SEWAGE DISPOSAL SYSTEM

HOWARD COUNTY HEALTH DEPARTMENT

SUBDIVISION Ashleigh Greene LOT 24, Sec. 1 ROAD 12124 Sudbury Court

Re: Septic System Plans
Ashleigh Greene, Section I - Lot 24
12124 Sudbury Court

INDICATE NORTH - NAME ADJOINING ROADWAY AS BASE LINE

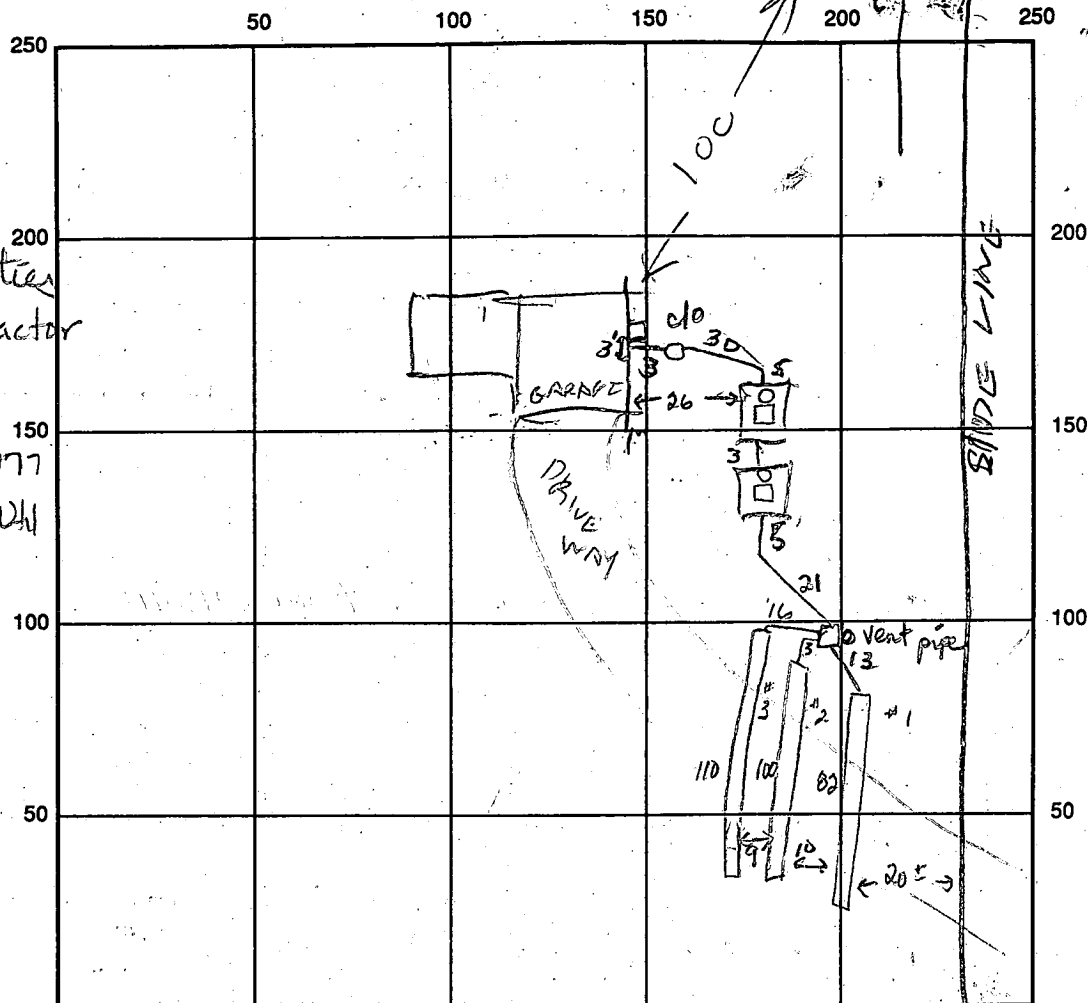
REMARKS: 8/2/91 - MEASURED LOCATION OF BOX ADVISED CONTRACTOR

3 TRENCHES ABOUT 95 FT LONG - HIGHEST TRENCH TO BE ONLY 10 FT FROM SIDE LINE. LOWEST TRENCH CAN BE LESS THAN 7 FT DEEP BECAUSE GROUND CUT (Rd)

8-6-91 OK to cover trenches. Need to run pumps & alarms. Need house connection

JEN, 8-7-91 House connection OK. JEN 1/6/92 ALARM FLOAT OK, PUMP

FLOATS NOT ACCESSIBLE; MANUALLY OPERATED FROM INSIDE - OK MR

ON OPP. SIDE OF MOUNTING POLE, MANHOLE TOO SMALL FOR LADDER)

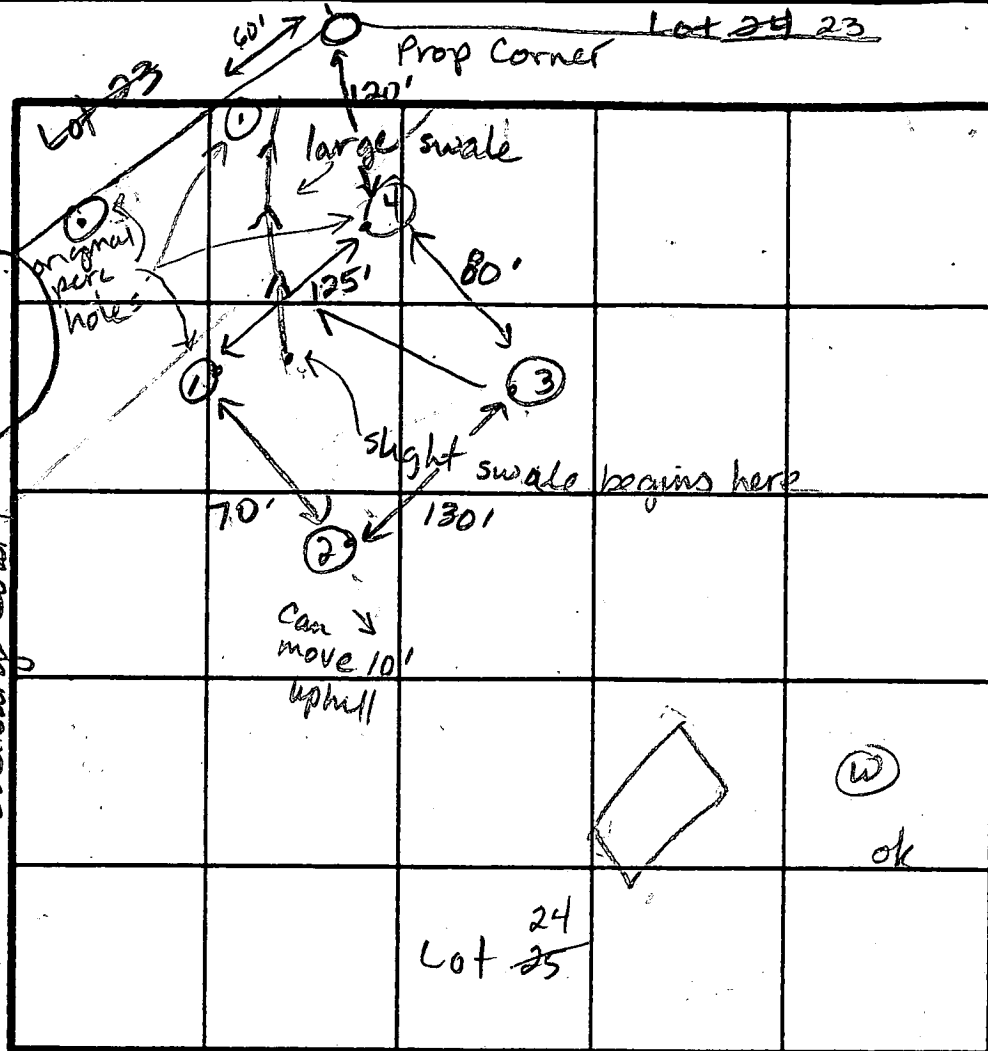
REASONS FOR REJECTION OR (HOLDING) 2-19-88 Pending subdivision plat approval and
perc hole locations. Keep septic field as high as possible. Can
move 10 ft uphill with corner #2. May have limited well site JEN
SHALLOW SYSTEM ONLY.

REMARKS Slight swale at lower end. Recommend moving field uphill 10 ft to obtain 10,000 sq ft area.

SHEET
4

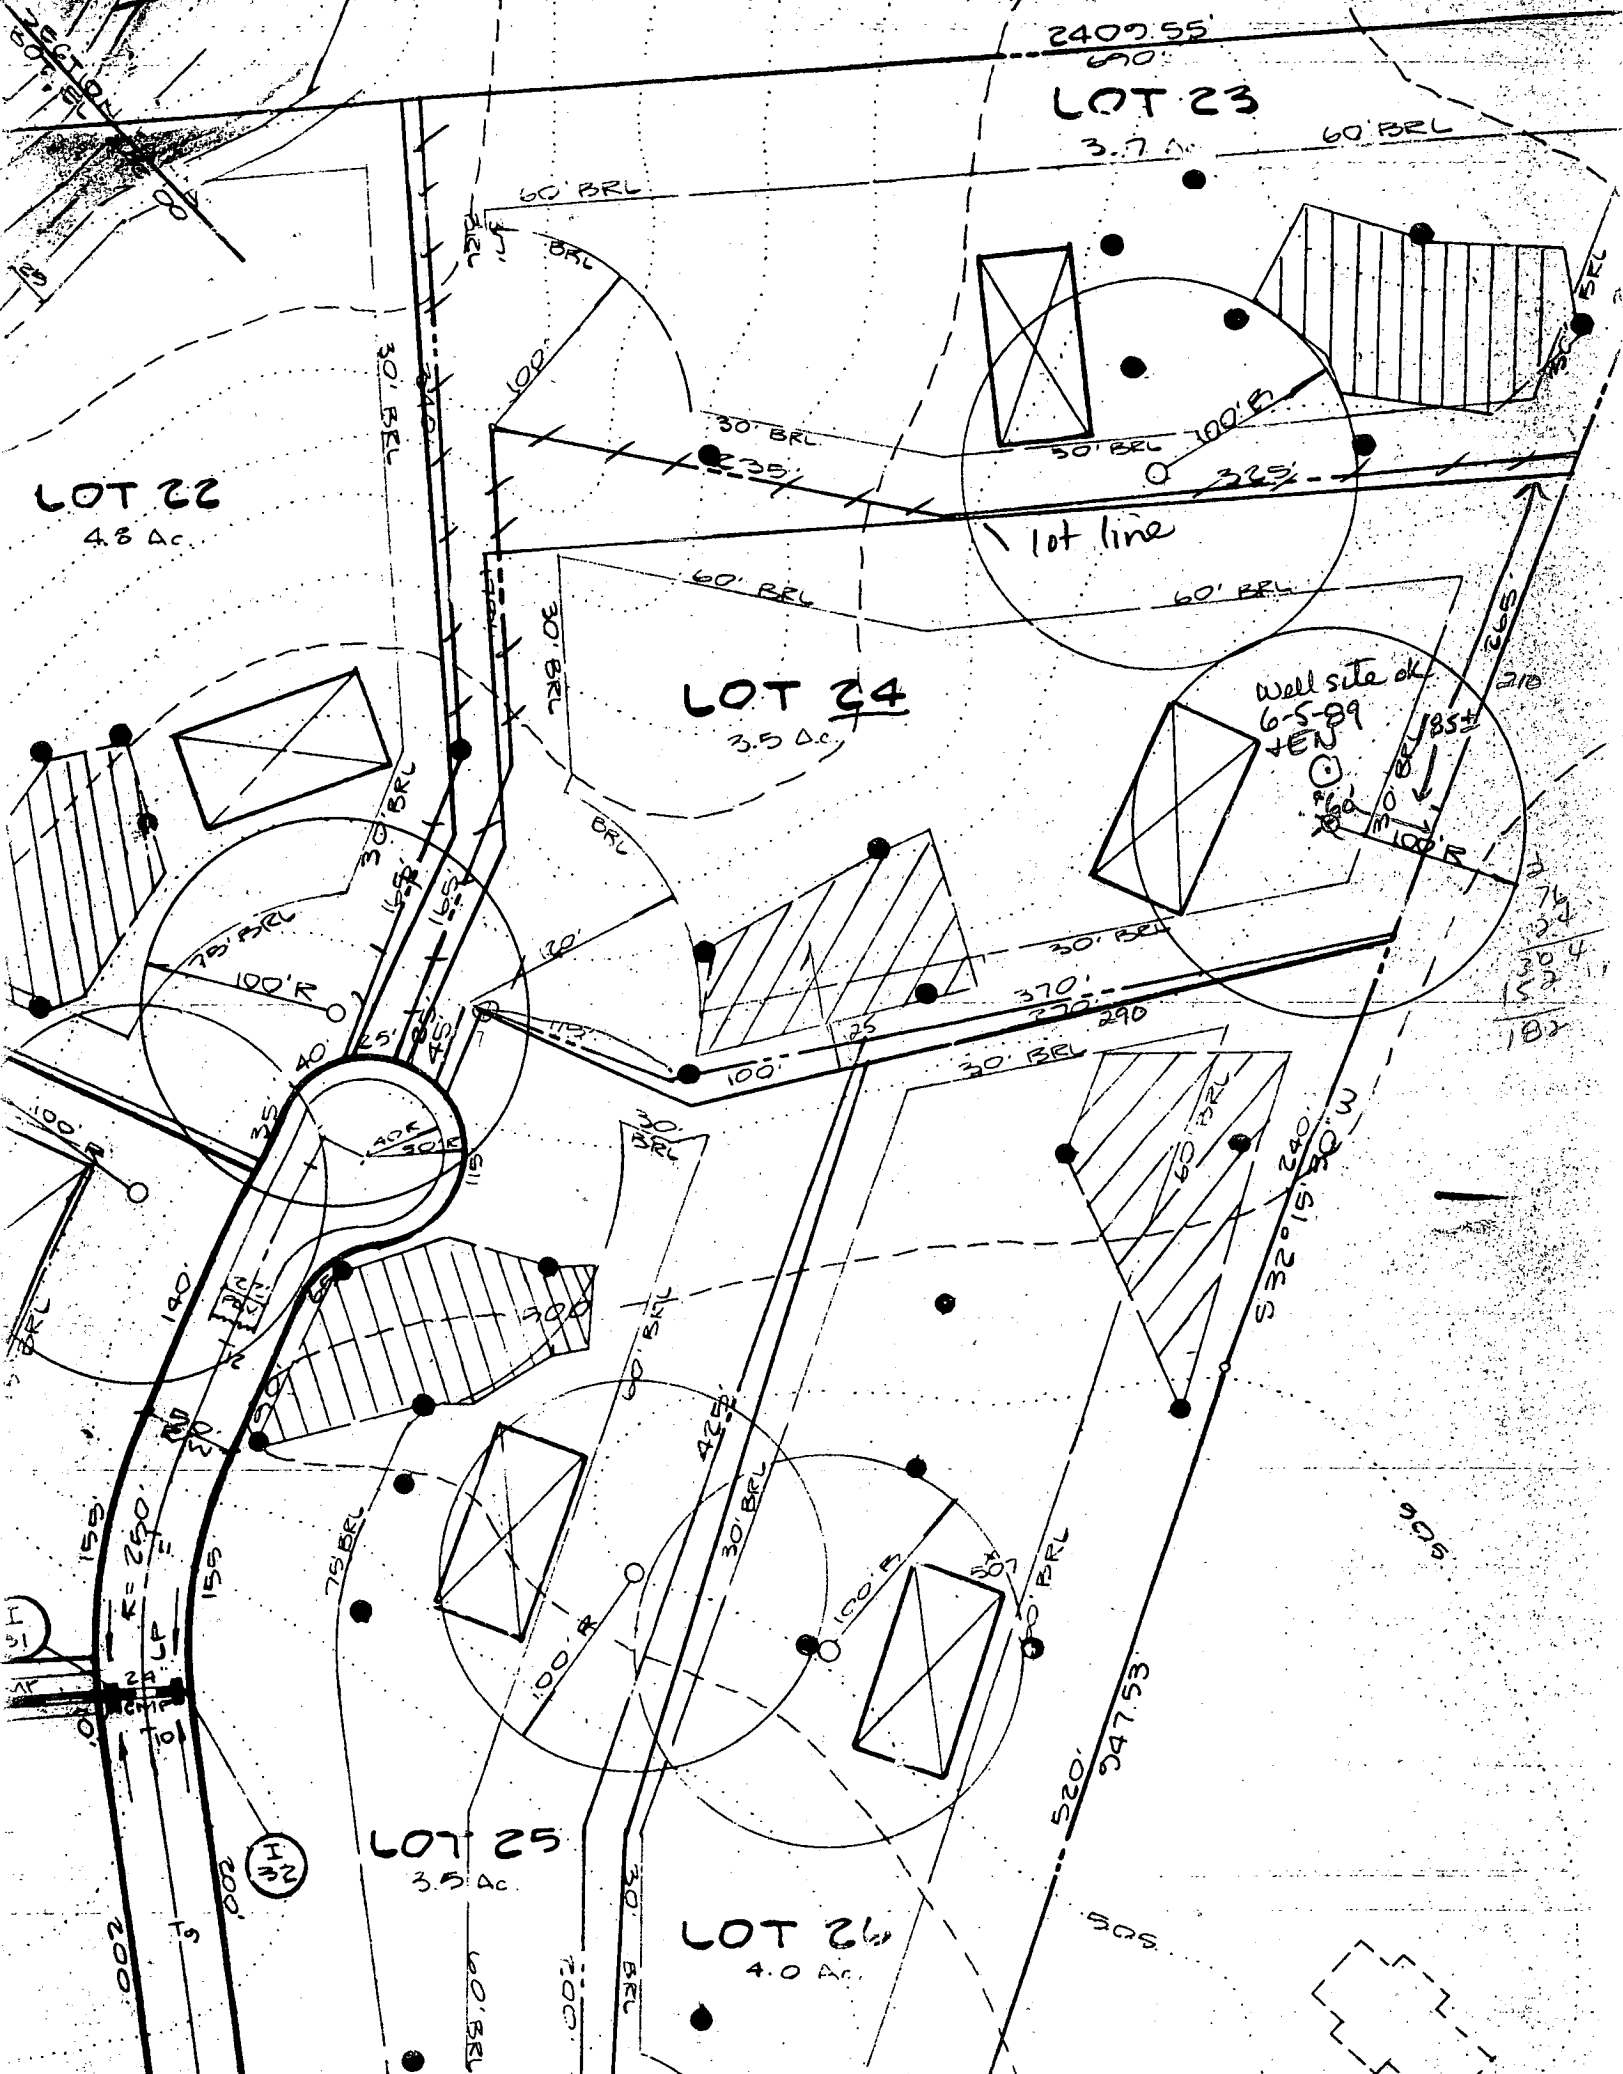
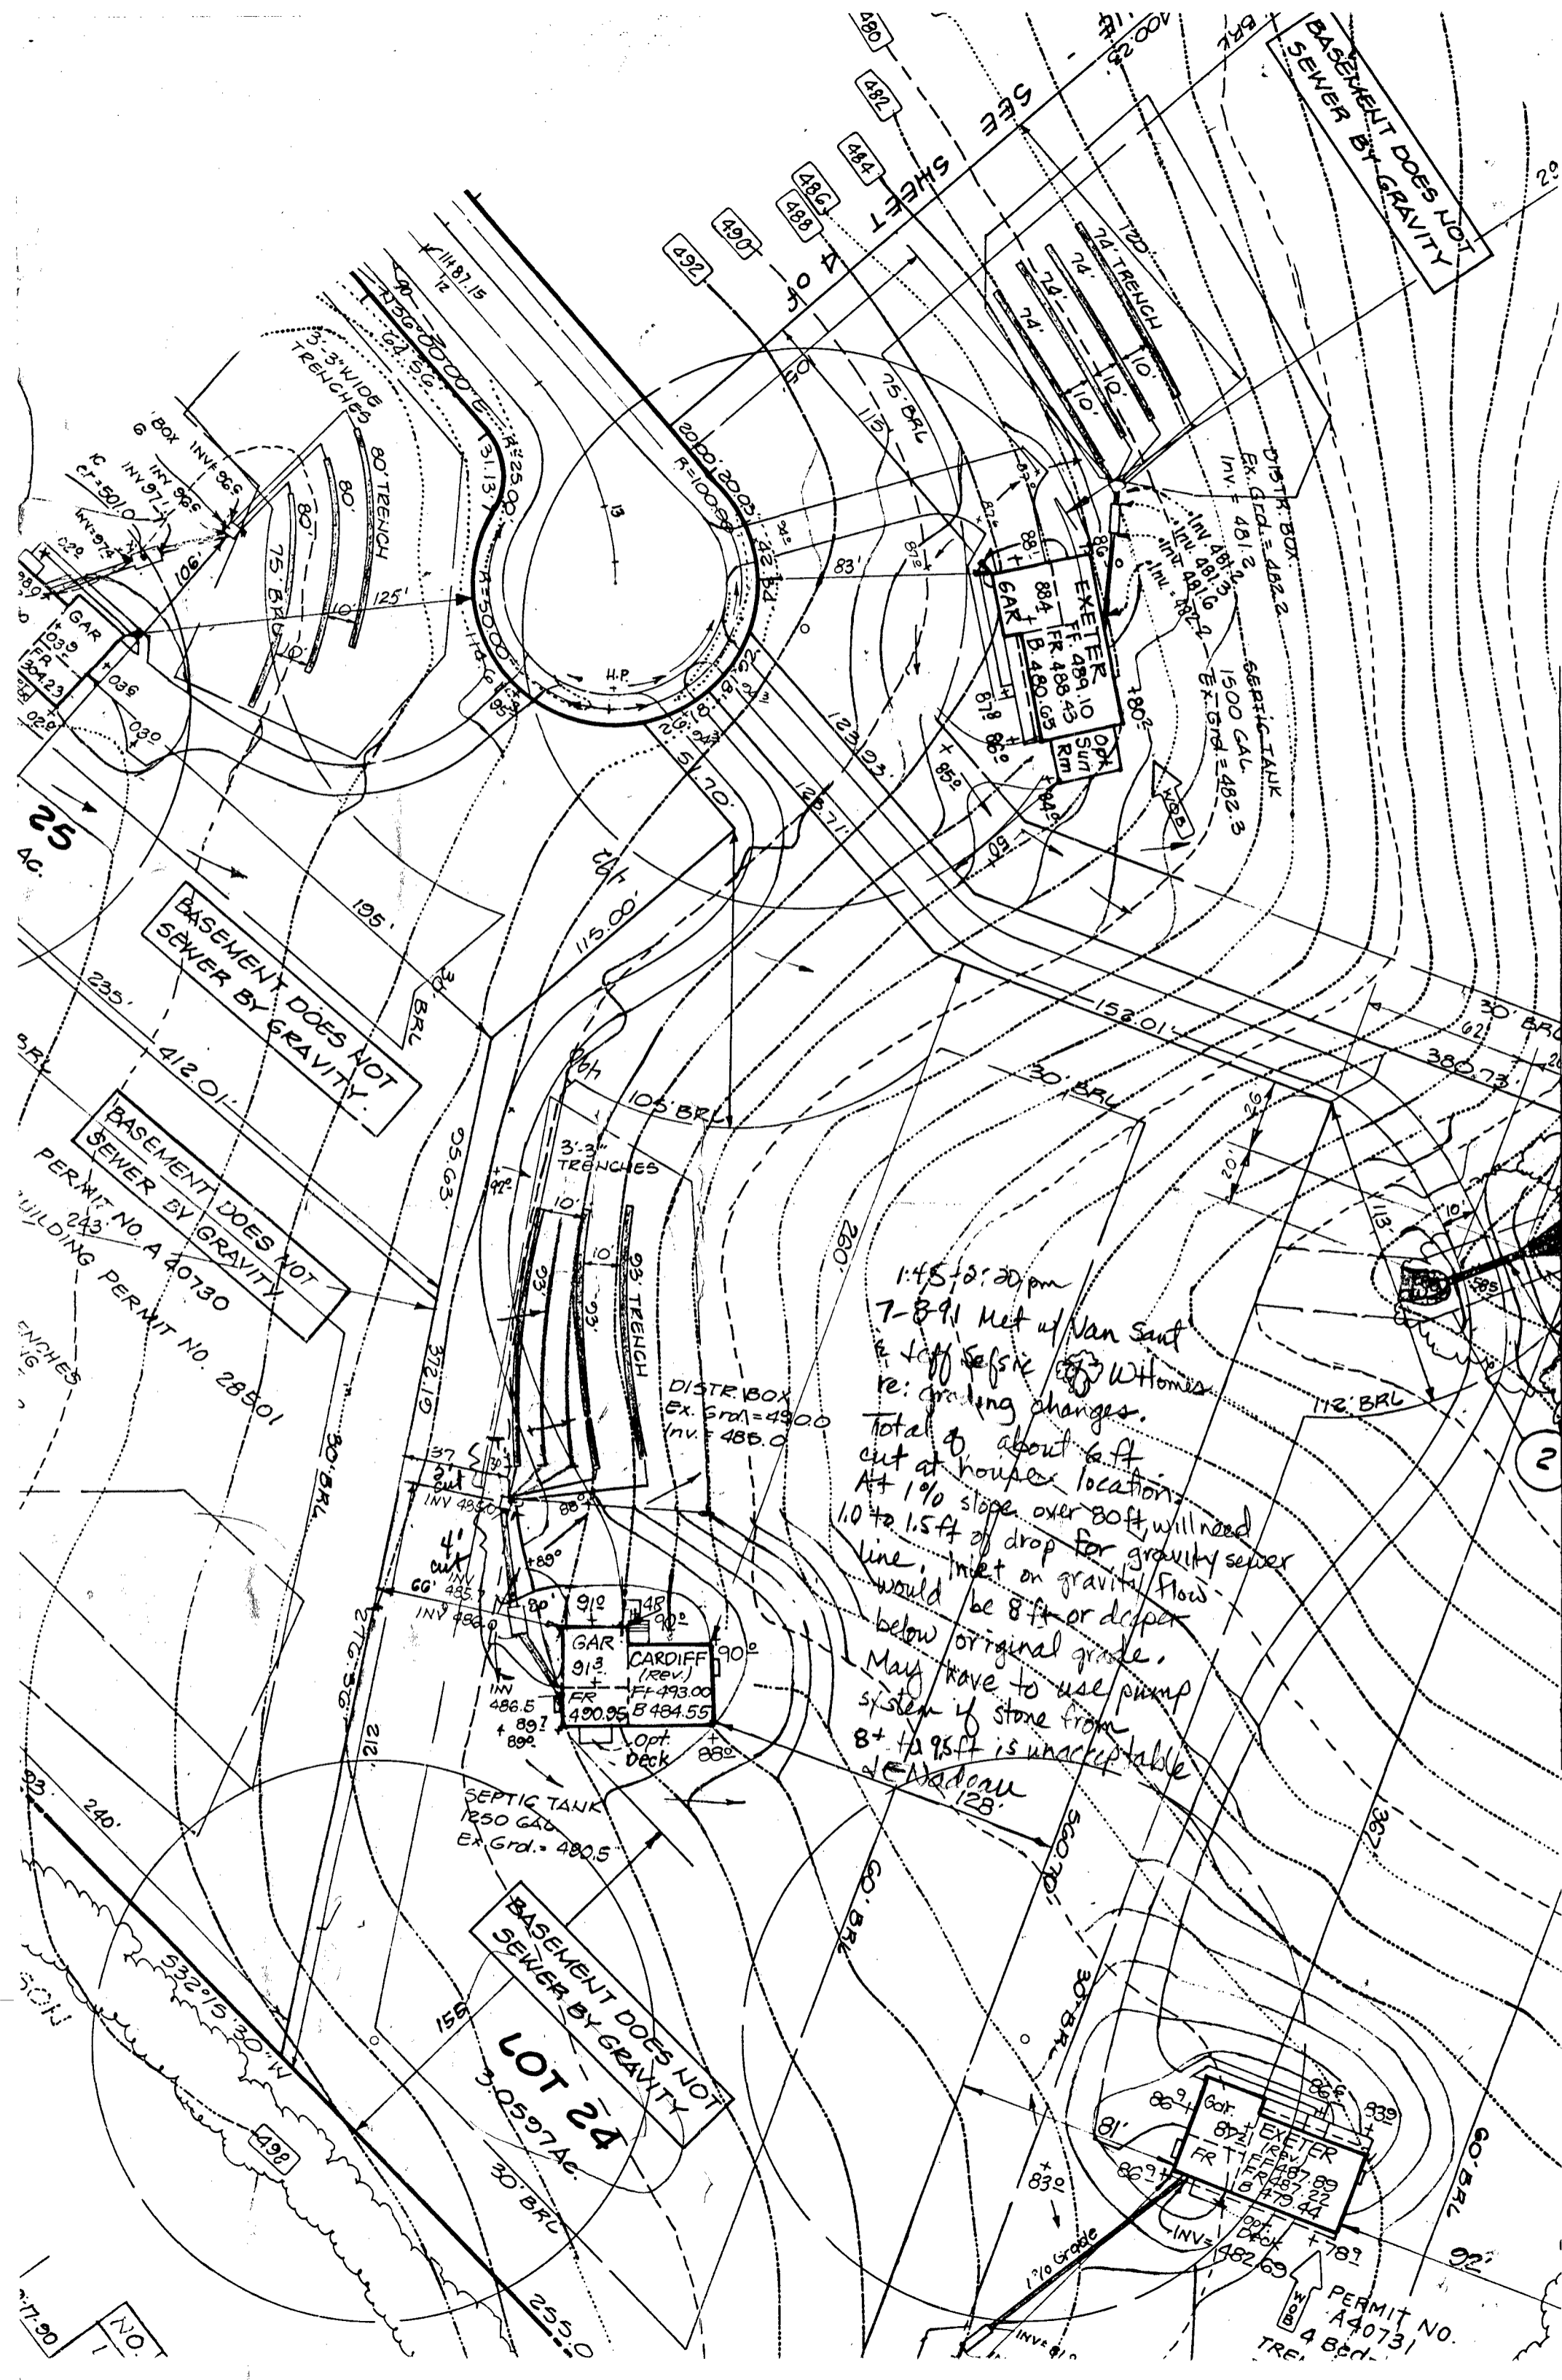
BASEMENT DOES NOT
SEWER BY GRAVITY

1:45 - 2:30 pm
7-8-91 Met w/ Van Sant
& Jeff Seftic of W.Homes
re: grading changes.
Total of about 6 ft
cut at house location.
At 1% slope over 80 ft, will need
10 to 1.5 ft of drop for gravity sewer
line. Inlet on gravity flow
would be 8 ft or deeper
below original grade.
May have to use pump
system if stone from
8+ to 95 ft is unacceptable
J. Madon
